Addendum #1

Project: Lewis & Clark Regional Water System – Rock County Reservoir
Bid Date: 2:00 P.M., Local Time, September 20, 2016
Bid Location: Lewis & Clark Regional Water System Office, 46986 Monty Street
Tea, SD 57064

Issue Date: September 16, 2016

1 / 5.1 RESERVOIR PROCESS PLAN

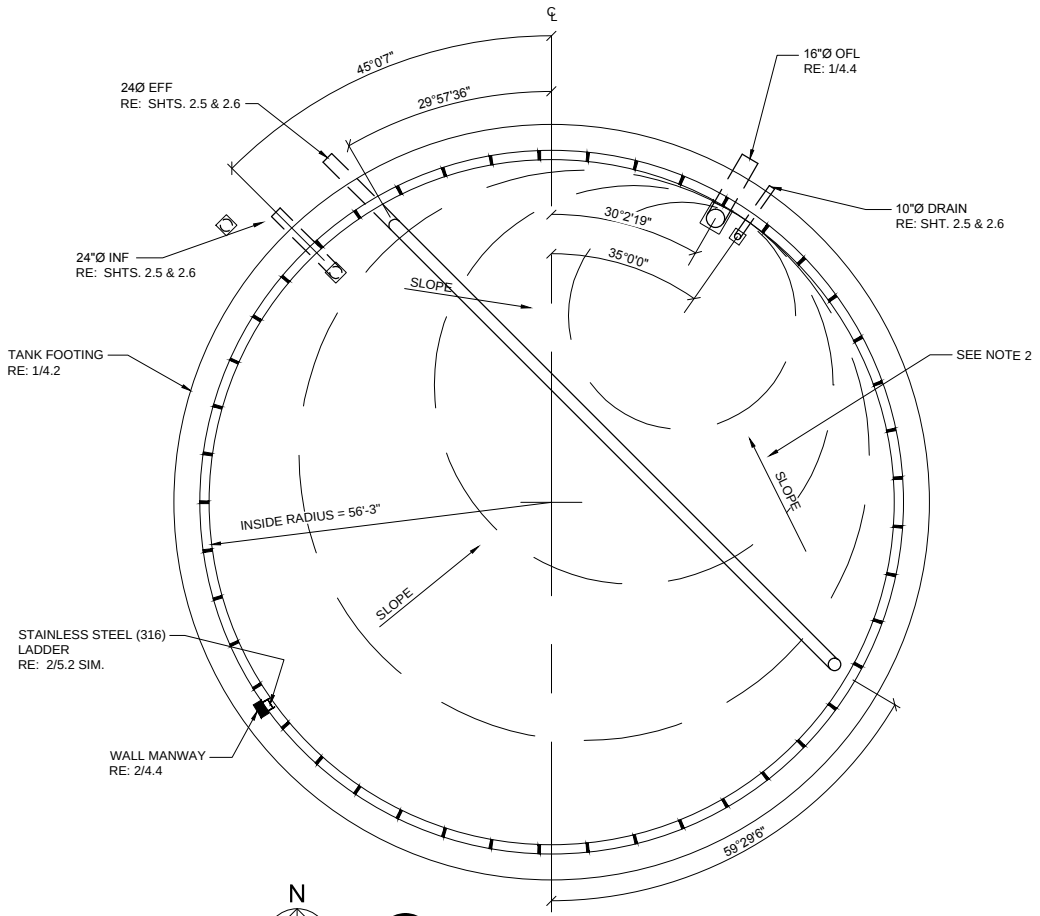
Detail 1/5.1 – RESERVOIR PROCESS PLAN DETAIL,

Delete: Remove detail in its entirety and replace with new detail as shown in attachment.

2 / 13.1 24" Ø EFFLUENT PIPE SECTION

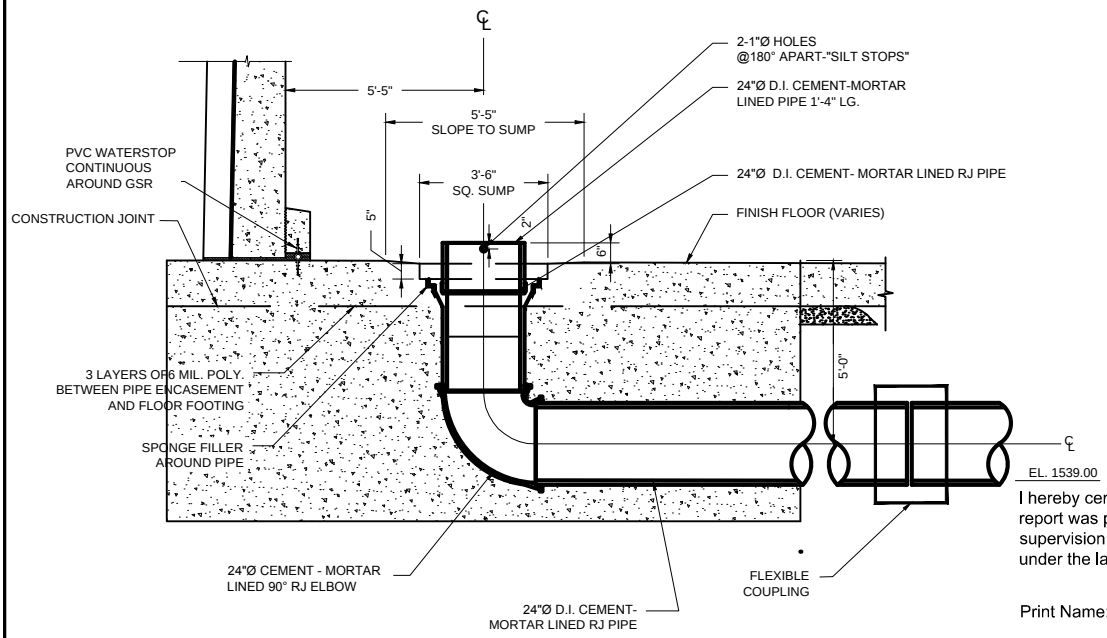
Detail 2/13.1 – 24" Φ EFFLUENT PIPE SECTION DETAIL,

Delete: Remove detail in its entirety and replace with new detail as shown in attachment.

Detail 2/13.1, 4/13.1 and 5/13.1 – PIPE SECTION DETAILS,

Delete: Remove the portion of the note that reads "(SPLIT SLEEVE)"

Clarification: Provide the flexible coupling at each of these locations as shown in Detail 5/2.6
